Mountain View Hospital - Medical Office Building Update

CITY OF LAS VEGAS			DATE:				
INTER-OFFICE MEMORANDUM			December 14, 2015				
TO: Land Development Services Department of Building & Safety			FROM: Albert Sung, P.E. Flood Control Project Engineer Department of Public Works				
SUBJECT: Drainage Study for:			COPIES TO:				
Mountain View Hospital – Medical Office Building Update			JPL Engineering				
Cross Streets: SEQ of Tenaya Way & Cheyenne Blvd.			Sunrise Mountain View Hospital				
File Number: F:\Depot\DSMemos\DS4749C.doc			Bart Anderson, P.E., DevCo				
Parcel Number: 138-15-612-013 & 138-15-612-014			NDOT				
Zoning Action: SDR-59940							
FEMA Flood Zone		YES				NO	X
Proposed Storm Drain		YES				NO	X

**ADDENDUM 2
TECHNICAL DRAINAGE STUDY**

**RE: ADDENDUM 2-UPDATE TO THE TECHNICAL DRAINAGE STUDY, MOUNTAIN VIEW
HOSPITAL – MEDICAL OFFICE BUILDING UPDATE
PERMIT NUMBER: DS4749A**

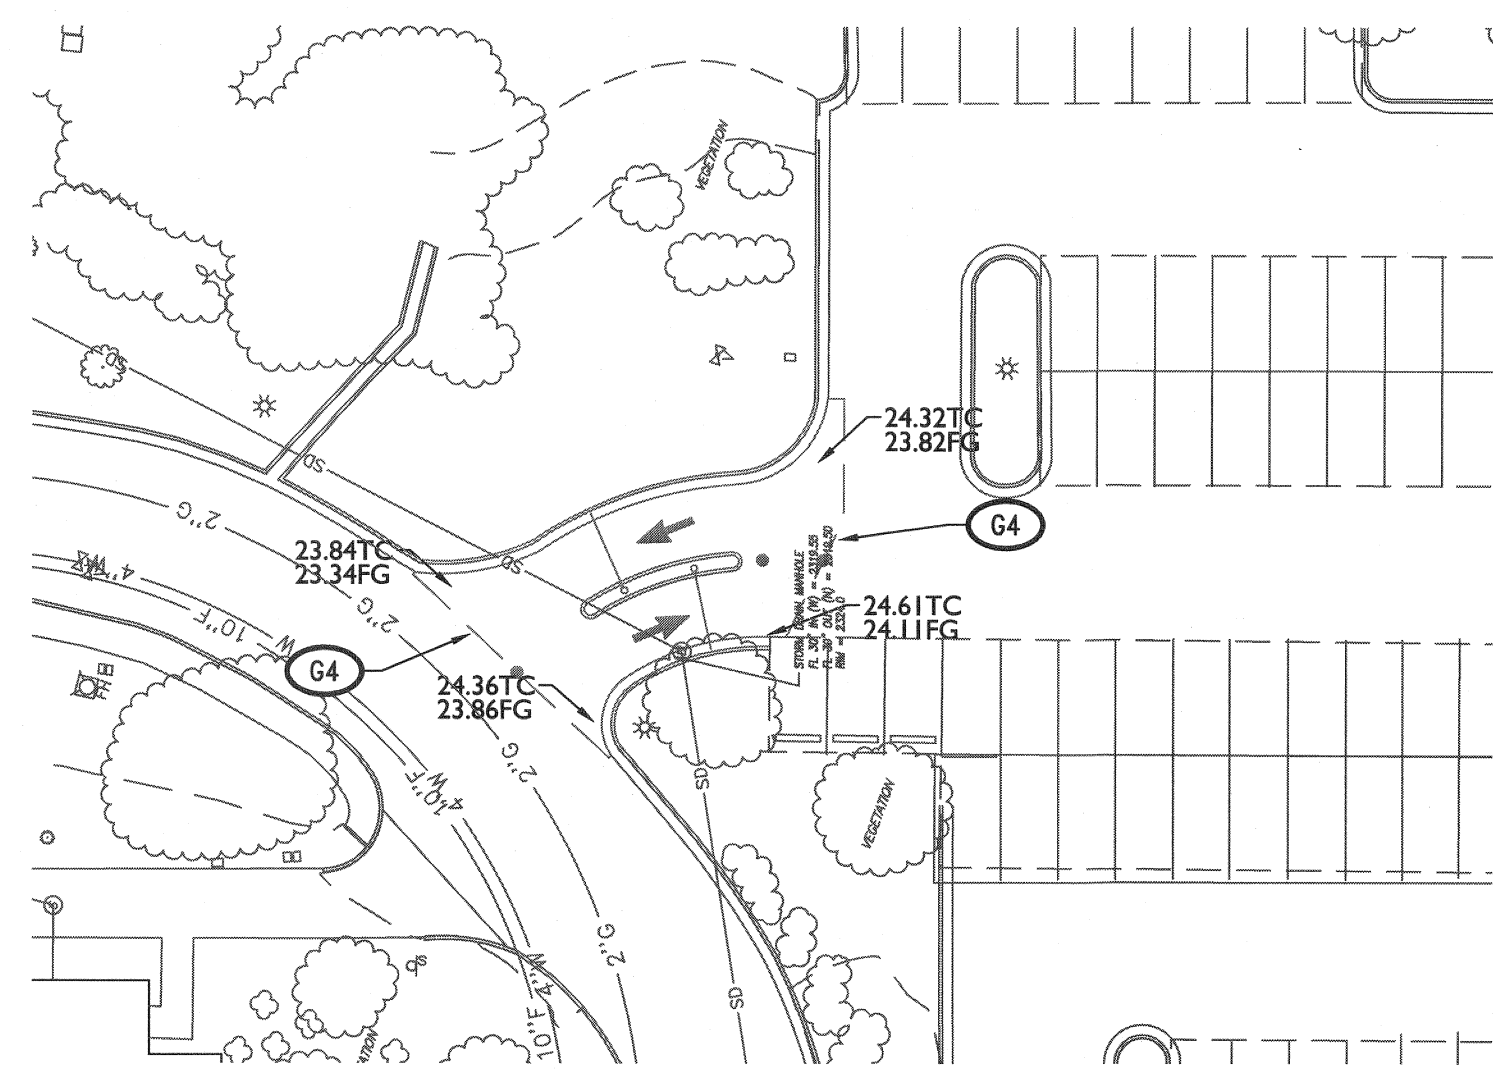
Comment 4: Sheet C6.0: Provide a bleeder line at drainage facility "F1" to daylight the flow.

Comment 5: Second request: Sheet C6.0: Identify and existing 24"-RCP culvert crossing US95 located at about the middle point of the east boundary of the project site. Label with recorded drawing number on the plan. Address in the addendum of the study whether this culvert is accepting any flow of the proposed development.

Response 4: The plan has been revised to eliminate construction of facilities in NDOT ROW. Per your conversation with George Huddleston (of Littlejohn) on 12/7/15, a bleeder line is not feasible due to the unavailability of a daylight location/elevation. As such, drawdown in structure F1 will be achieved via an exfiltration pipe/trench. The pipe between structures F2 and F1 will be perforated pipe to allow exfiltration, and the attached drainage memo has been included (Appendix B) to demonstrate that the volume is drawn-down within 24 hours (within 6 hours, in fact).

Response 5: Per your discussion with George Huddleston (of Littlejohn) at the 11/24 Civil Express Review, this drawing number information was not included in our project survey. However, all storm water discharge is routed to an on-site manhole and no infrastructure is proposed within the NDOT right-of-way. As such, the information has not been provided on the plan.

Response 7: This note has been added to sheets C6.0 and C6.1.

SHEET
C6.1

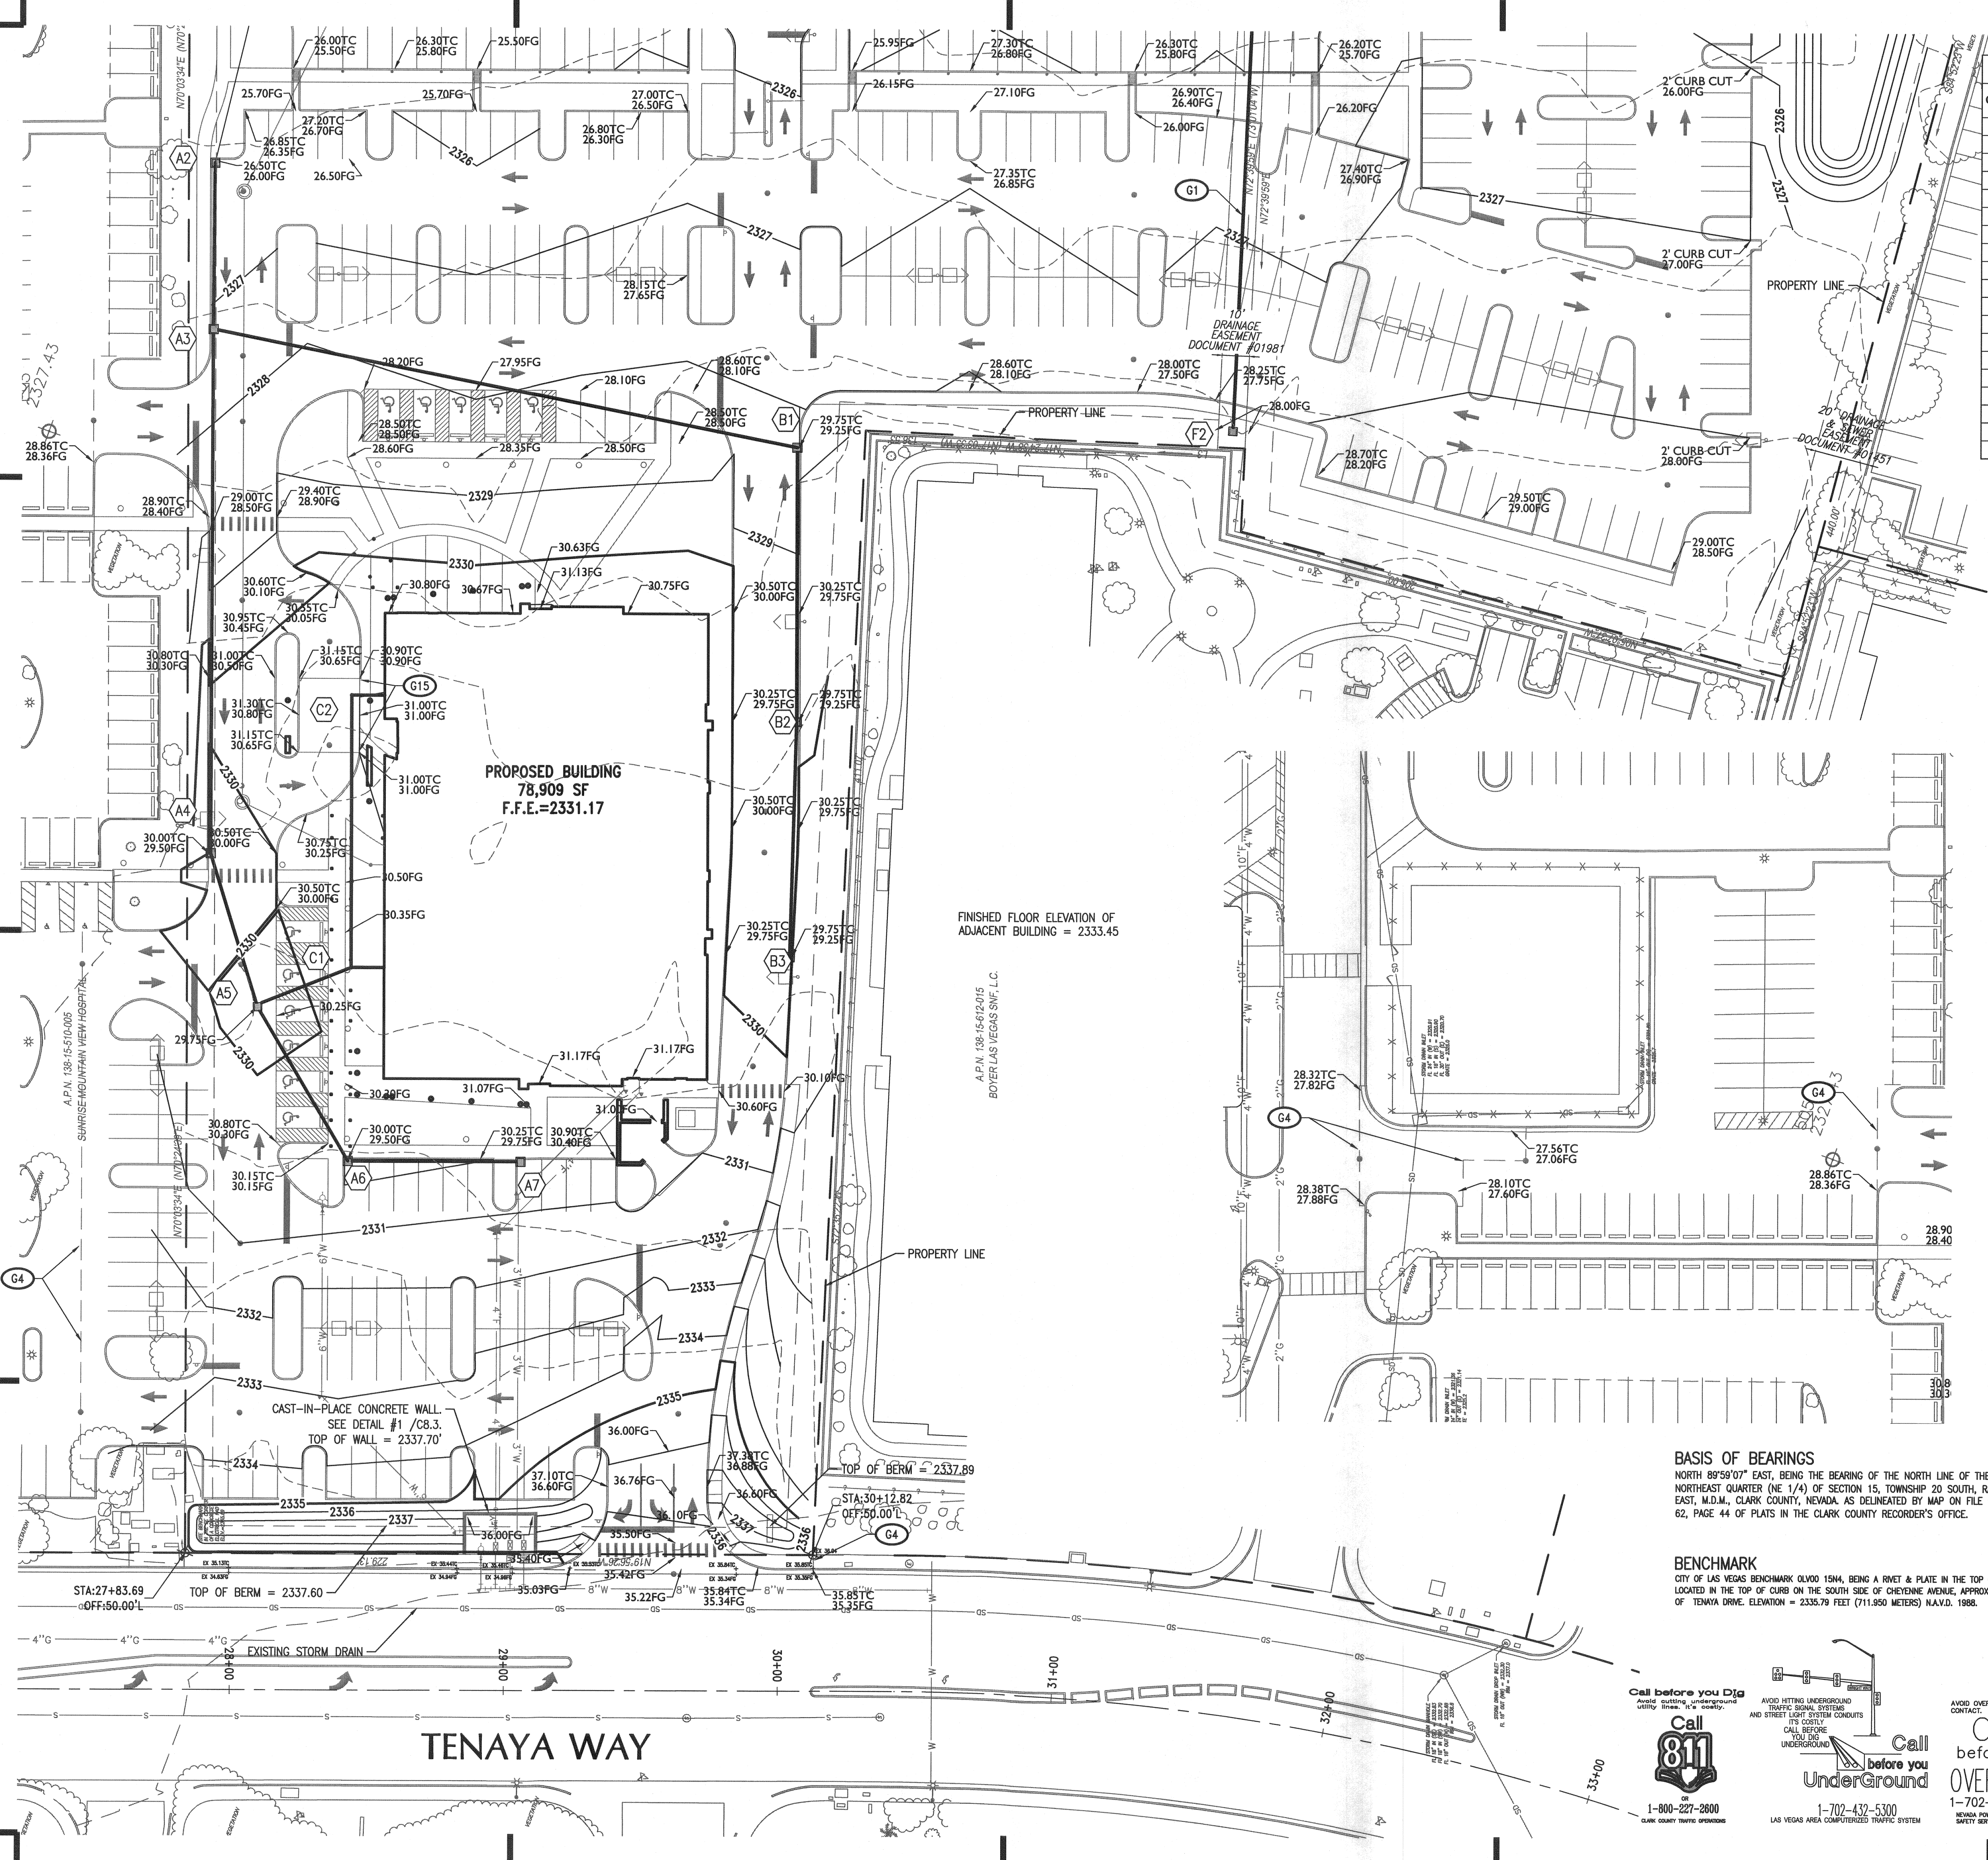
Comment 2: Sheet C6.1: It appears that drainage facility "F2" is located in the adjacent property. Either obtain a notarized letter of permission for construction from the adjacent or property owner or relocate the inlet easterly into the subject site. Review and revise accordingly. Also, explain why the proposed inlet is so deep.

Comment 3: Sheet C6.1: Identify the property line of the adjacent property to the west.

Response 2: Drainage structure F2 is not located on the adjacent property. There may have been some confusion as to where exactly the property line lies. As such, the property line has been darkened and called out to avoid any further confusion.

Response 3: The property line has been identified on all sides of the proposed project.
